## Flint WTP Improvements – Phase II, Segments I, II and III

### Responses to MDEQ Review Comments dated 3/19/2014

3/19/14  
Consultant's Resp.  
to MDEQ Comments  
on WTP Upgrade

**Flint WTP Improvements  
Phase II  
Segments I-III  
MDEQ Comments  
March 19 , 2014**

1. Raw Water Piping – Maintain back-up supply from Gen Co. during interim operation at C.S. #2. Sheet C5-102

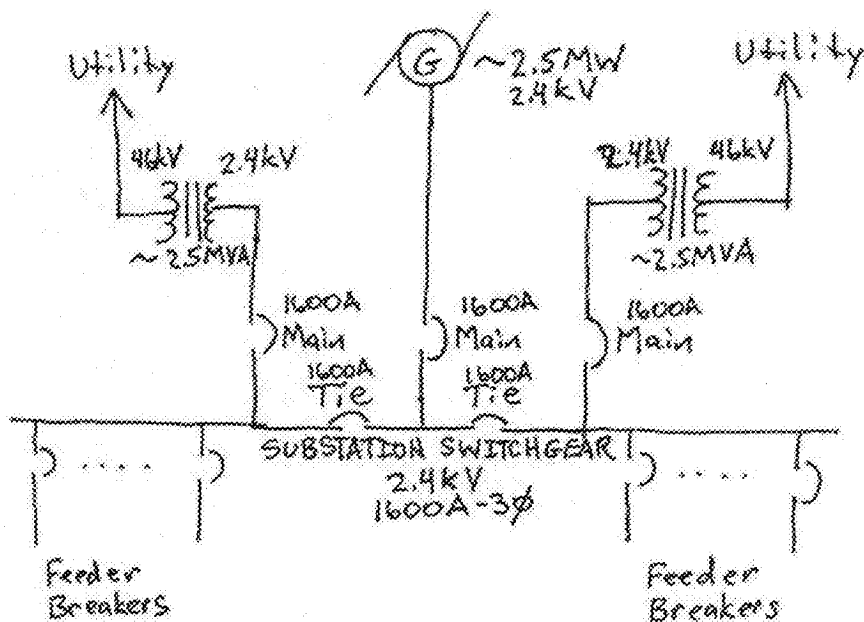
54X42 cross (Sheet C5-501 & C5-101) only 6-inches – Support?

Air-release manhole – same as Cut-in piping

Current yard piping diagram?

- b. The crossing of the new 42" steel pipe over the existing 54" concrete pipe is shown in plan on drawing sheet C5-101, with Detail 5, Sheet C5-501 showing how the 42-inch line will be supported. As shown on Detail 5, Sheet C5-501, the new 42-inch line will have concrete pipe cradles constructed on either side of the existing 54" pipe, maintaining a minimum clearance of 12" on either side of the 54" pipe. Pipe loads from the 42" line will then be transferred to the pipe cradles and into the soil, and not the 54" pipe. The 6" clearance between the two pipes will be backfilled with CLSM material as it will be impossible to compact typical granular bedding material under the 42" pipe.

- c. Detail 2, Sheet C5-505, "Air Release & Access Manhole," shows a 2" corp stop for air release. These are intended to be manual air release valves for exhausting air upon initial filling of the pipeline or after maintenance has been performed and refilling the pipeline. The manhole structure will be checked periodically and pumped out with a portable sump pump as part of the normal plant maintenance program.

- d. See attached color coded yard piping diagram.
2. Midpoint Chlorination
  - a. Four (4) new scales will be provided for monitoring chlorine usage from ton containers. Scales shall be as manufactured by Scaletron Industries Ltd. with a load range of 0 to 4000 lbs.

Flint WTP - Preliminary One-Line Diagram

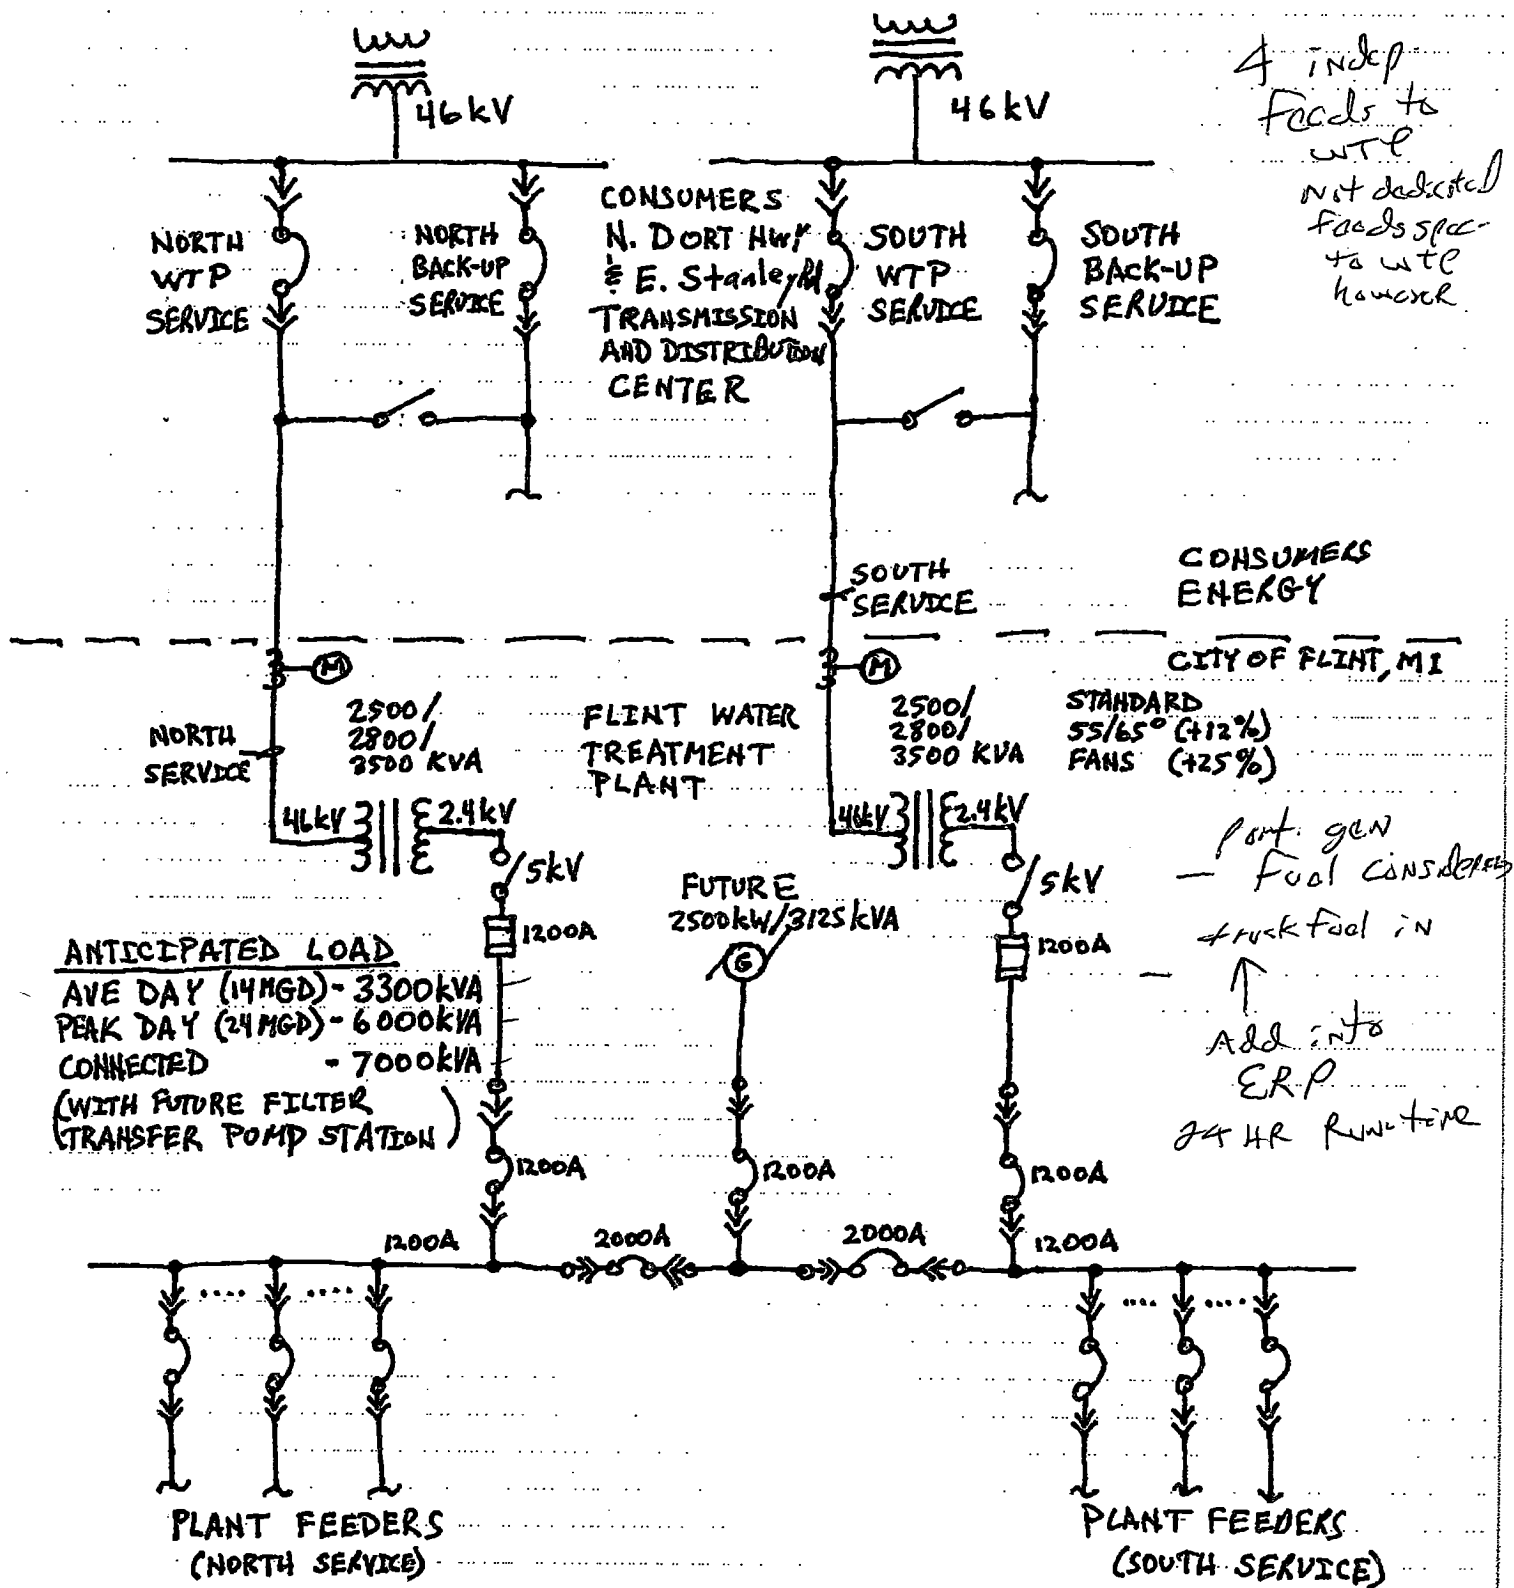
Would you please review and provide any comments that you may have.
